**Addendum #2
Issued January 12, 2018
BID #28-18**

CITY OF PORTSMOUTH

On-Street Bicycle Facility Improvement Project, Lafayette Road/Middle Street

This Addendum forms part of the original document marked “New Hampshire Project #28757, Federal Project # X-A003(791), On-Street Bicycle Facility Improvement Project, Lafayette Road/Middle Street BID#28-18.”

**DETAIL "A"
 PEDESTRIAN ACTUATED
 CROSSING ASSEMBLY**

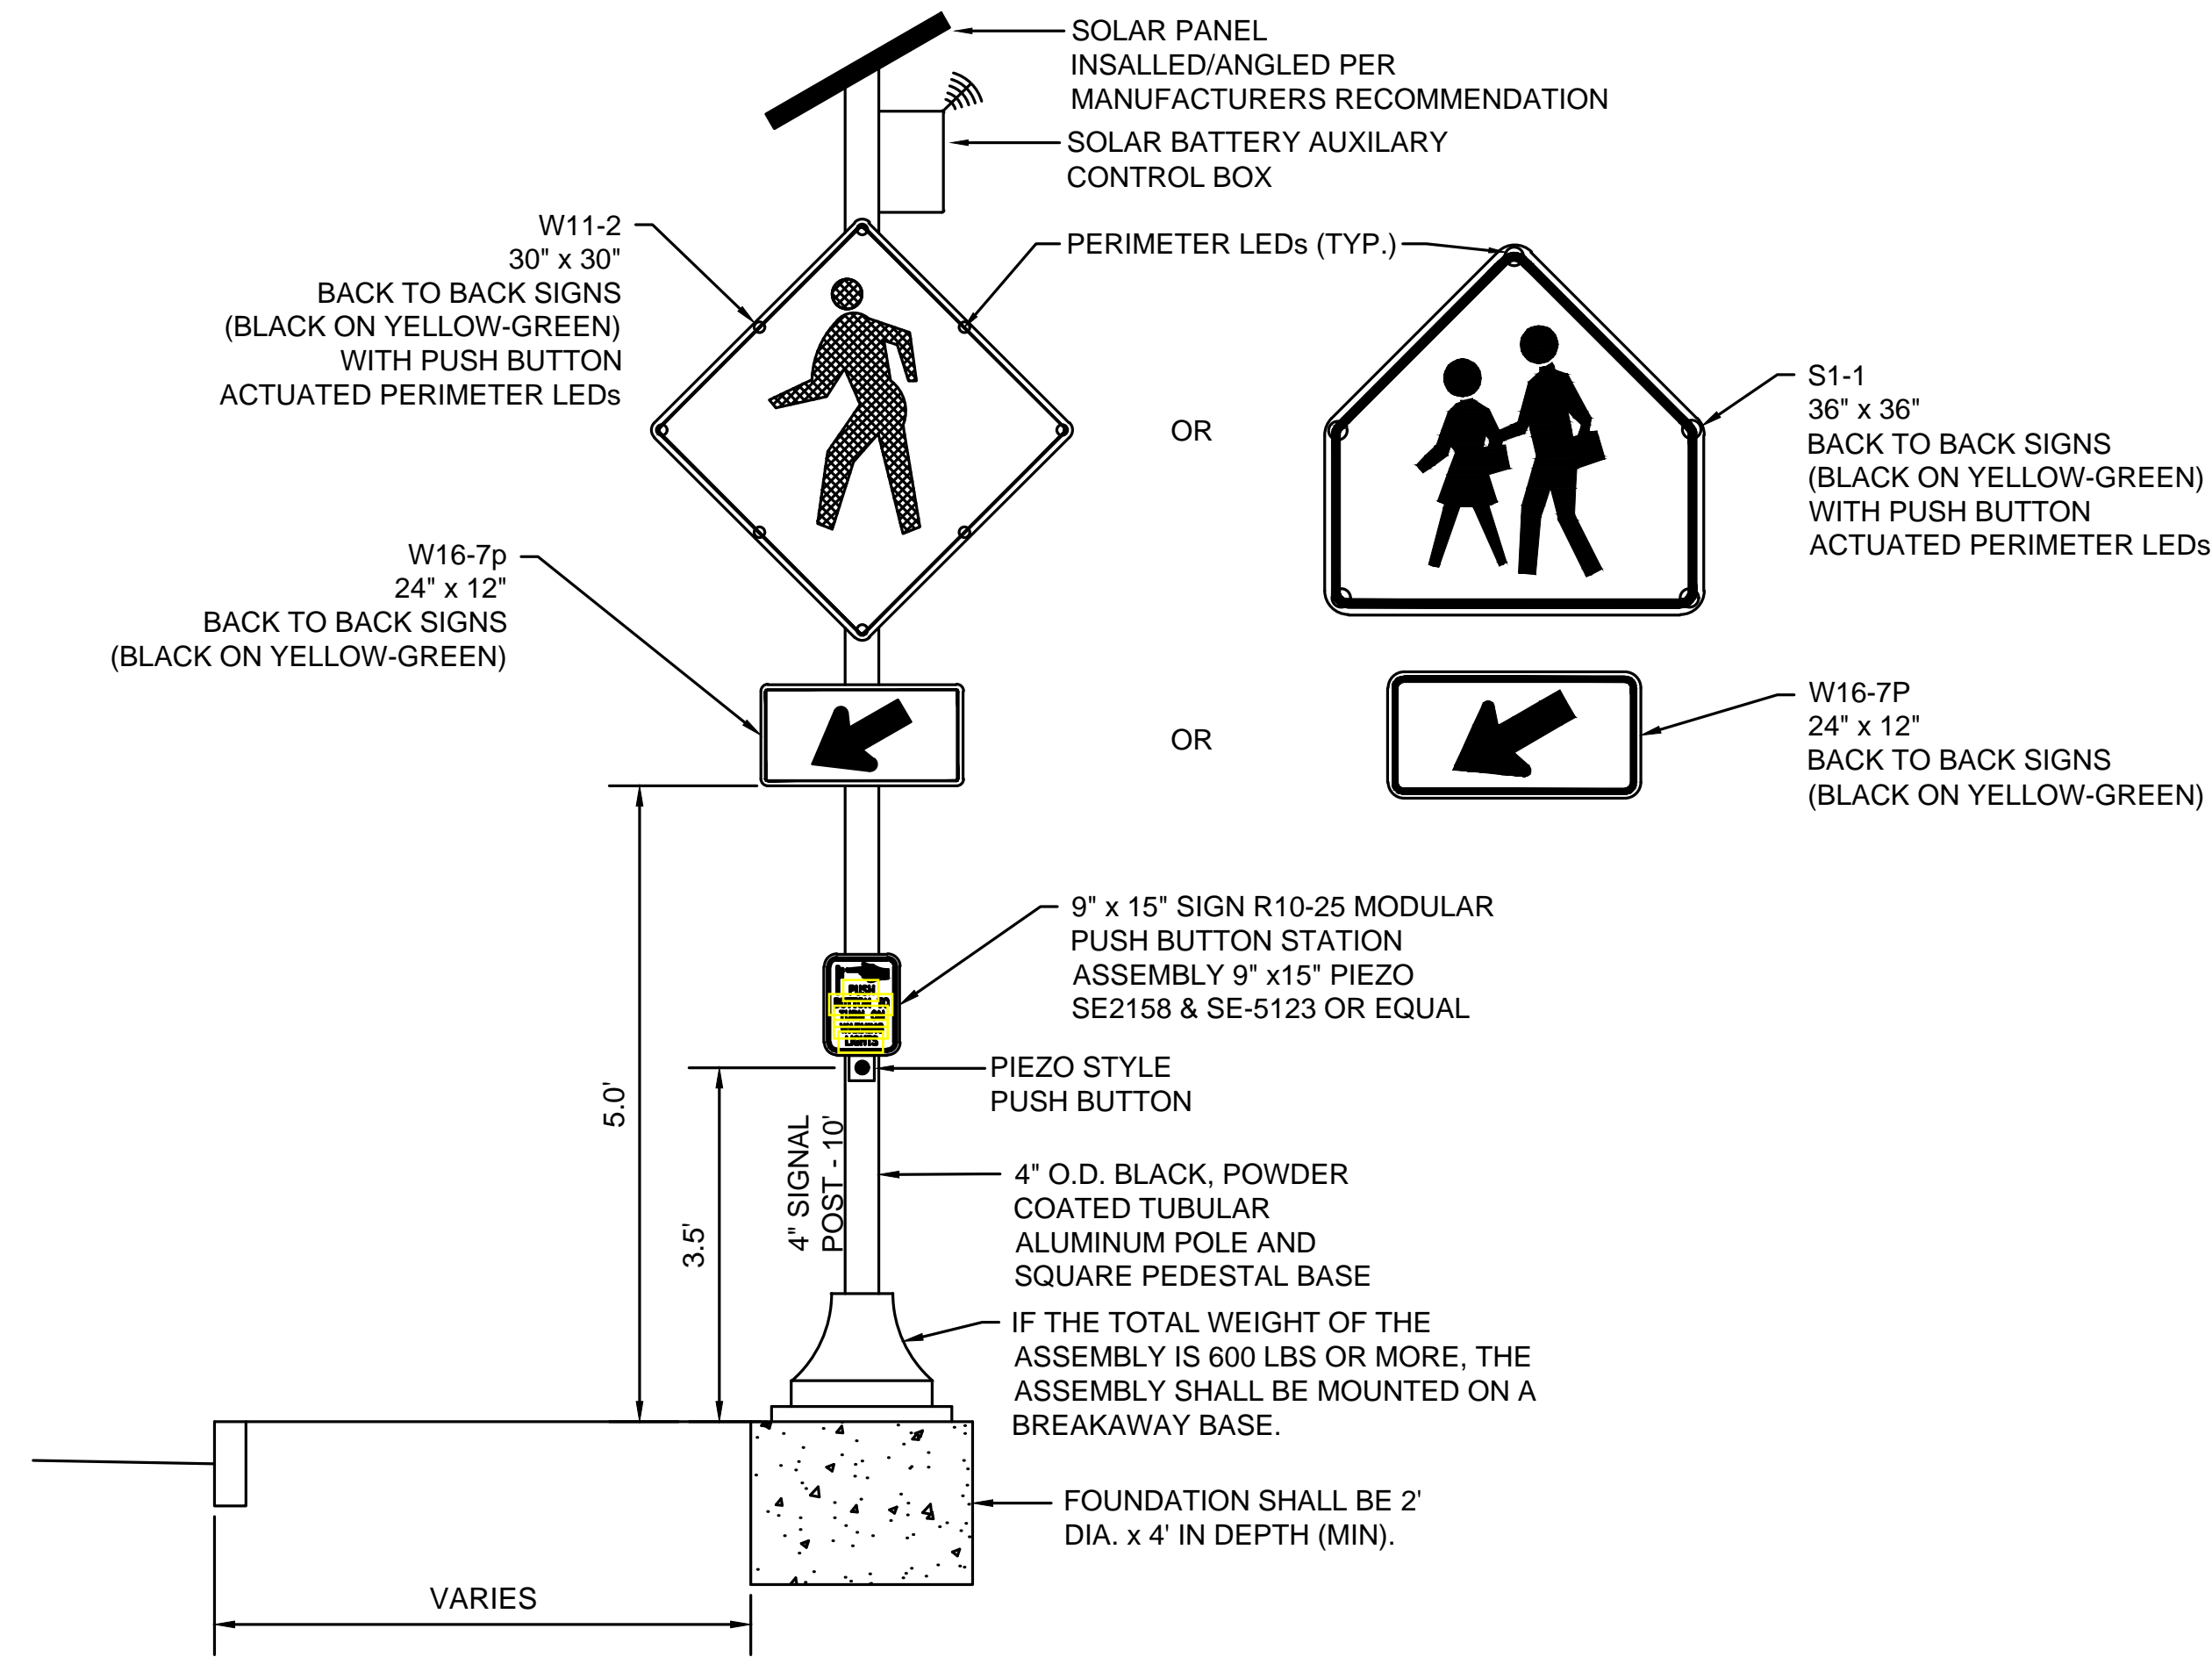
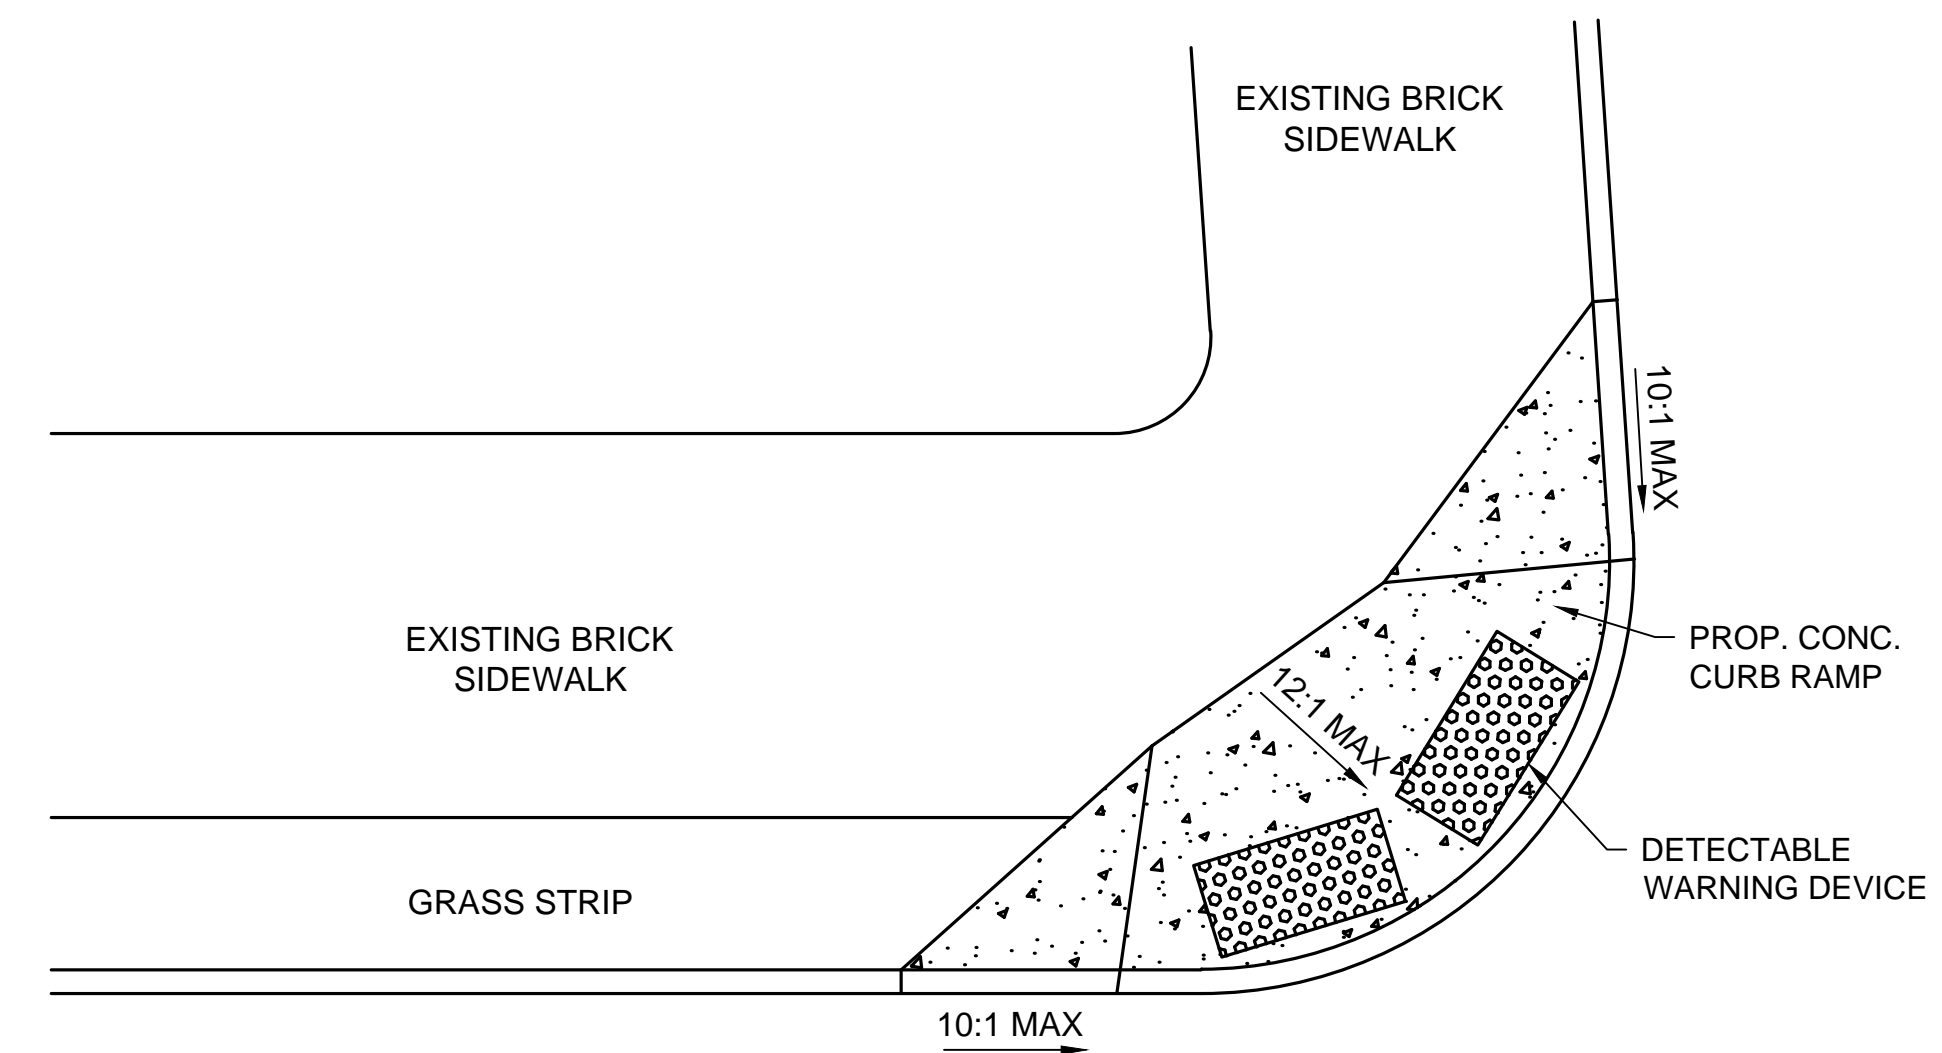
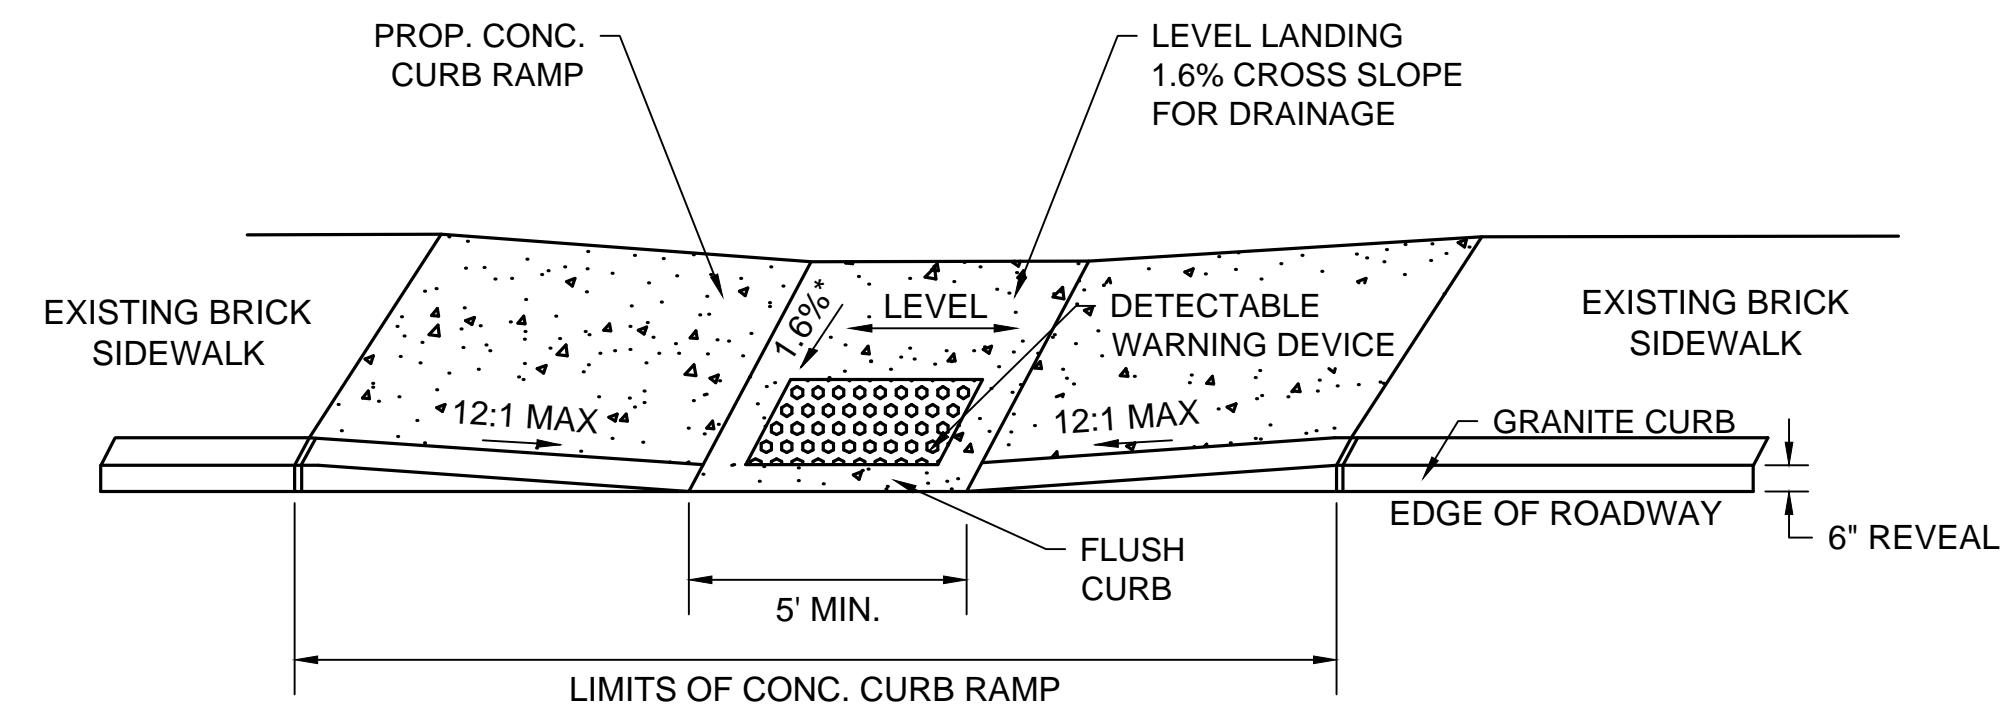
3. Given FHWA's recent decision to rescind their interim approval of Rectangular Rapid Flashing Beacons (RRFBs), this addendum delete's all references to RRFB's and replaces "rectangular rapid flashing beacon crossing assembly" with "pedestrian actuated crossing assembly". The intent is that the project will utilize the pedestrian actuated crossing assembly at the same locations noted on the plans for RRFBs but will instead use warning signs with flashing LEDs in the border as detailed herein.

Sheet 38 of the bid plans shall be replaced with the attached revised sheet 38.

1. WHERE THE CROSSING ASSEMBLY INSTALLATION IS ADJACENT TO A UTILITY POLE, THE ASSEMBLY SHALL BE LOCATED ON THE SIDE OF THE UTILITY POLE SO THAT IT IS CLEARLY VISIBLE BY ONCOMING MOTORISTS IN THE ADJACENT TRAVEL LANE. WHERE THIS OCCURS, AND THE VISIBILITY OF THE W11-2/S1-1 AND W16-7P ARE BLOCKED BY THE ADJACENT UTILITY POLE; THE W11-2/S1-1 AND W16-7P SHALL BE MOUNTED ON A SEPARATE U-CHANNEL POST ON THE DEPARTURE SIDE (OF THE ADJACENT TRAVEL LANE) OF THE UTILITY POLE. THE COST OF THE U-CHANNEL POST AND TO PERFORM THIS WORK IS INCIDENTAL TO ITEM 616.21.

2. FINAL LOCATIONS OF THE CROSSING ASSEMBLY WILL BE COORDINATED IN THE FIELD WITH THE ENGINEER.
3. TREE TRIMMING NEEDED TO IMPROVE VISIBILITY OF THE CROSSING ASSEMBLIES SHALL BE INCIDENTAL TO ITEM 616.21.

4. PUSH BUTTON SHALL BE ORIENTED TO FACE MOST ACCESSIBLE LOCATION ON ADJACENT SIDEWALK AS DIRECTED BY THE ENGINEER.
5. CROSSING ASSEMBLY FOUNDATION SHALL BE FLUSH WITH ADJACENT SIDEWALK TO ALLOW FOR SIDEWALK PLOW PASSAGE.

6. POST AND BASE SHALL BE BLACK, POWDER COATED.
